RENOVATION OF DEPARTMENT OF HEALTH CARE FINANCE SPACE

DCAM-13-CS-0086

RESPONSE TO OFFEROR RFI'S

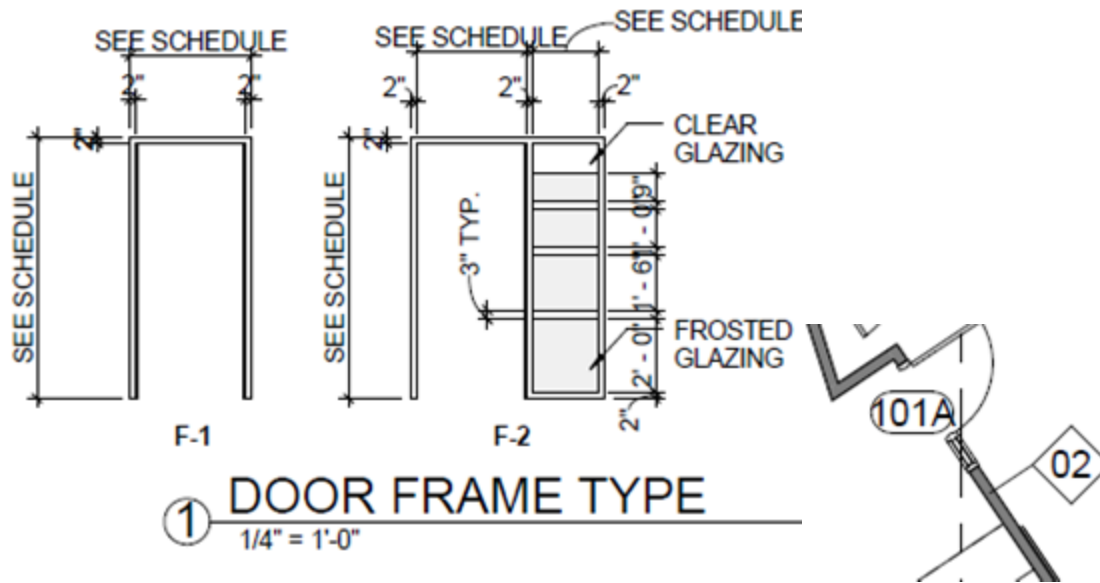
Q16. Can you clarify the specifications for Carpet? The finish schedule calls for composite tile and the spec book has a section for sheet carpet. We need a specification.

A16. See response to question 8.

Large Conference Room 213 – Carpet Tandus, Style- Artisan, Color-Llama, Director’s Room 101 – Carpet Lees, Collection- Vacant Beauty, Color- Cherished Runs, Manager’s Offices - Carpet Tandus, Style- Visa, Color-Whirl Pool, Open Offices (Cubicle) and Corridor - Carpet Lees, Collection- Vacant Beauty, Color- Remnants.
